**MODIFICATION      REQUEST:      Hume  
Highway - Woomargama Bypass**

**(08\_0237 MOD1)**

***Modification to permit increased flooding  
inundation levels associated with the bridging  
of Mountain Creek***

Director General's  
Environmental Assessment Report  
Section 75W of the  
*Environmental Planning and Assessment Act 1979*

**Figure 2 – Difference in flood extent**

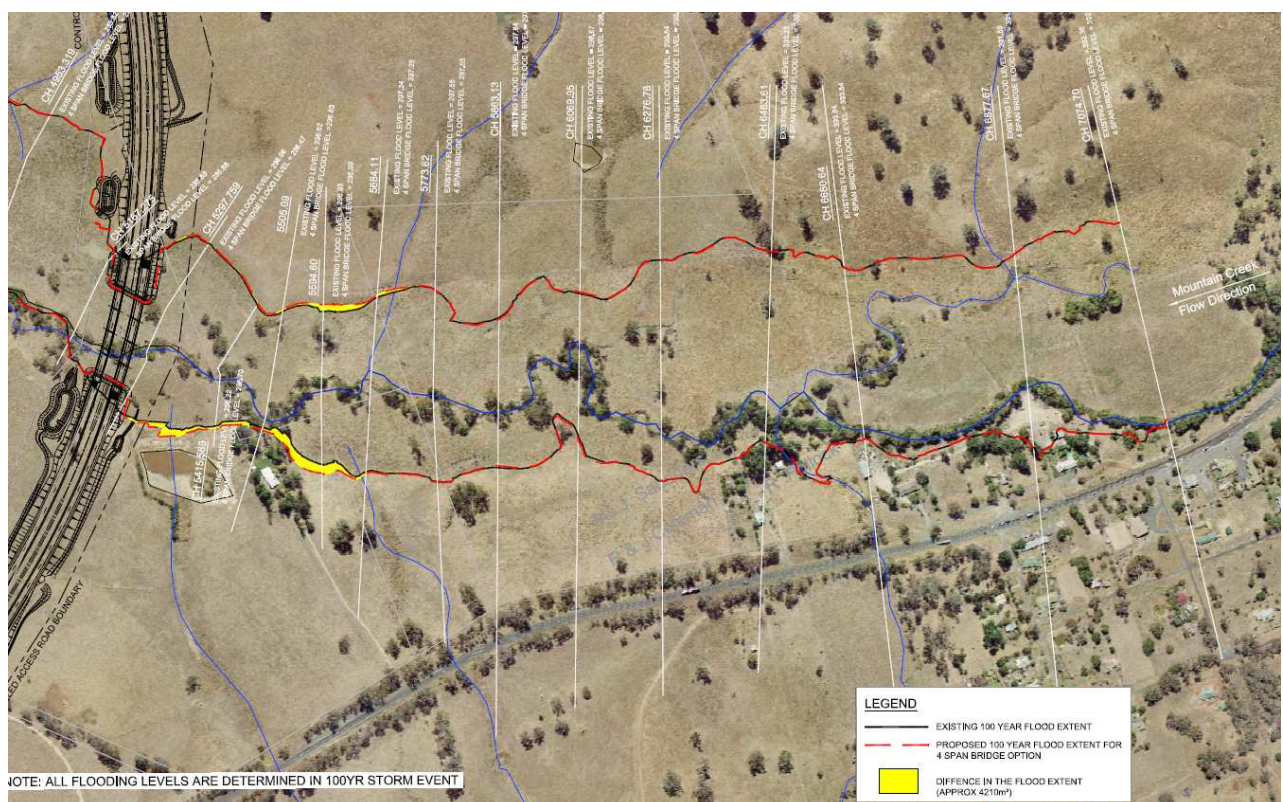
The proposed four span bridge results in a maximum afflux of approximately 480mm approximately 200 metres upstream, reducing to zero approximately 500 metres upstream. The flooding impacts remain wholly contained within the floodplain. At the location where afflux is greatest the width of the flow would marginally increase from 180 metres to 190 metres and the greatest increase in width of flow would be 25 metres at approximately 300 metres upstream (see Figure 2).

The impact of the flooding is the primary issue for consideration. Modelling shows increases of up to 0.48m for the four span bridge option compared to existing conditions. In addition, near the bridge where floods level and extents increase, the time period which the existing 1 in 100 year flood is exceeded would be about six hours, both of which are significantly higher than the levels provided for in condition 2.25. However, about 600 metres upstream of the bridge, the hydrographs of the existing and four span bridges are identical.

Notwithstanding, this increased flooding impact will be confined to the existing floodplain area, with the width of the flood extent increasing by up to 25 metres approximately 300 metres upstream of the bridge. The Department is satisfied that this increase in width is minor in the context of the overall flooding impact, as is evidenced by Figure 2. Further, the flooding impact is contained to land that is owned by the RTA and is unable to be substantially developed in the future as it is zoned rural (as advised by Greater Hume Shire Council in accordance with Holbrook Interim Development Order 1970). The Department is satisfied that there would be no adverse impacts as a result of the relatively minor flooding changes due to the land being zoned rural, and the absence of any dwelling or other structure in the affected area.

- 2.26A Notwithstanding condition 2.25 the detailed design of the bridges at Mountain Creek shall limit to the greatest extent practicable, increases in flooding characteristics between the bridges and a point 600 metres upstream of the bridges to those identified in modification request 08\_0237 MOD1 and in particular shown on Drawing No. NB11038-SK-DR-0006 Rev E.
